**TOWN OF MOUNTAIN VILLAGE
REGULAR DESIGN REVIEW BOARD MEETING AGENDA
THURSDAY MAY 5, 2022 10:00 AM
MOUNTAIN VILLAGE TOWN HALL
455 MOUNTAIN VILLAGE BLVD, MOUNTAIN VILLAGE, COLORADO
TO BE HELD HYBRID THROUGH ZOOM:**

RE: Staff Memo – Review and Recommendation to Town Council Regarding a Major Planned Unit Development Amendment to the Lot 109R Planned Unit Development, commonly called the Mountain Village Hotel PUD, by Tiara Telluride, LLC.

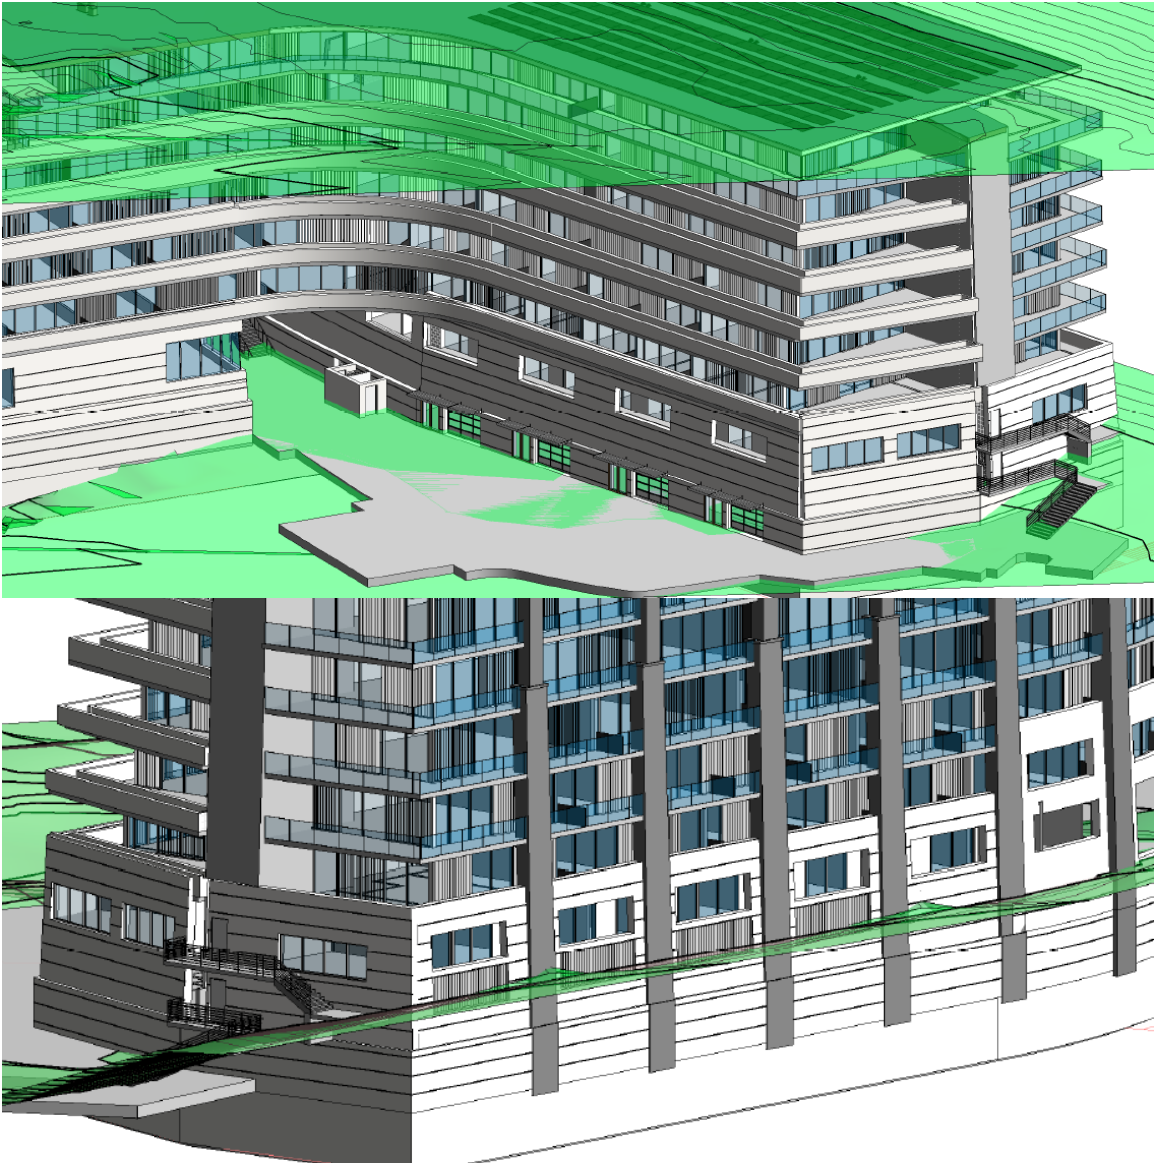
Staff has worked with the applicant through multiple revisions to have the building height drawings show compliance with the prescribed method of measuring height per the CDC. Because this is a complex form it is difficult to demonstrate height compliance solely in elevation views. A 3D planar view was required to show that no portion of the roof (with the exception of the chimney) penetrates the projected plane of the requested height. The applicant has provided this projected plane for both proposed and existing grade and the only element projecting beyond these planes is the chimney. This seems to demonstrate compliance, however the proposed grade shown doesn't represent reality. There are a few points in in this 3D view that don't make sense. In the NW perspective view you can see that the proposed grade shown is above the pedestrian access through the building. In the SW perspective you can see both exterior stairways extending below the proposed grade. The SE perspective shows the proposed grade seeming to hit the building partway up a window or screen area.

The applicant will need to revise the 3D planar view of the proposed grade to ensure that the building is not exceeding the requested max height of 96' 8".
